Access Compliance Report

Public Rights-of-Way

(Curb Ramps)

Intersection ID: N/A	Main Street: TUCKASEEGEE_RD	Cross Street: N/A	Location: N
ADA ID: 4610053C4765	Ramp Type: Perp	Initial Pass/Fail: Fail	Overall Compliance: No
Severity Score: 22.5			
Codes/Mitigation Info/Possible Solution		Field Measurements/Component Compliance

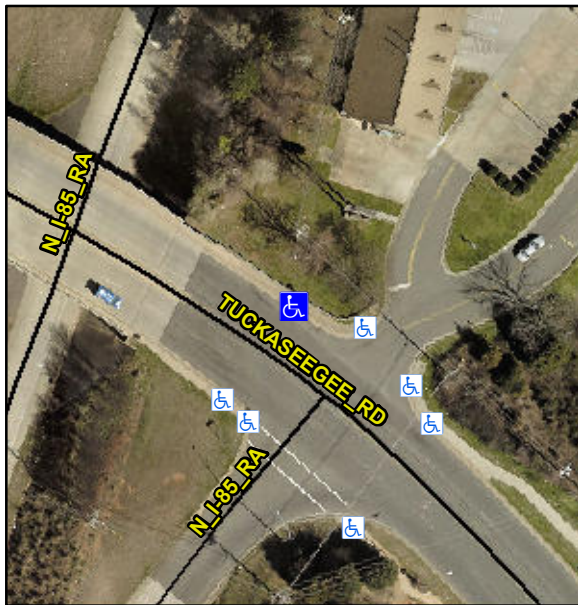
Not Found, R304.5.1, R304.2.2, R304.5.3

Compliance	Description	Data	Compliance	Description	Data
N/A	Ramp Length (in)	60.0	No	Ramp Slope (%)	8.7
No	Ramp Width (in)	44.0	No	Ramp XSlope (%)	4.1
N/A	Flare Type LT	N/A	N/A	Flare Type RT	N/A
N/A	Flare Slope LT (%)	N/A	N/A	Flare Slope RT (%)	N/A
N/A	Flare Traversable LT?	No	N/A	Flare Traversable RT?	No
N/A	Landing Length (in)	N/A	N/A	DWS Provided?	N/A
N/A	Landing Width (in)	N/A	N/A	DWS Contrast?	N/A
N/A	Landing Slope (%)	N/A	N/A	DWS Length (in)	N/A
N/A	Landing X Slope (%)	N/A	N/A	DWS Full Width?	N/A
N/A	Landing Curb? (Y/N)	N/A	N/A	DWS Offset (in)	N/A
N/A	Shared Landing?	N/A			
N/A	Gutter Ponding?	N/A	N/A	Gutter Slope (%)	N/A
N/A	Gutter Lip Ht (in)	N/A	N/A	Gutter X Slope (%)	N/A
N/A	Painted X Walk1?	No	N/A	Painted X Walk2?	N/A
	X Walk 1 Direction	To SW		X Walk 2 Direction	N/A
N/A	X Walk 1 Width (in)	N/A	N/A	X Walk 2 Width (in)	N/A
	X Walk 1 Slope (%)	2.1		X Walk 2 Slope (%)	N/A
	X Walk 1 X Slope (%)	3.0		X Walk 2 X Slope (%)	N/A

Remove & Replace Entire Ramp.
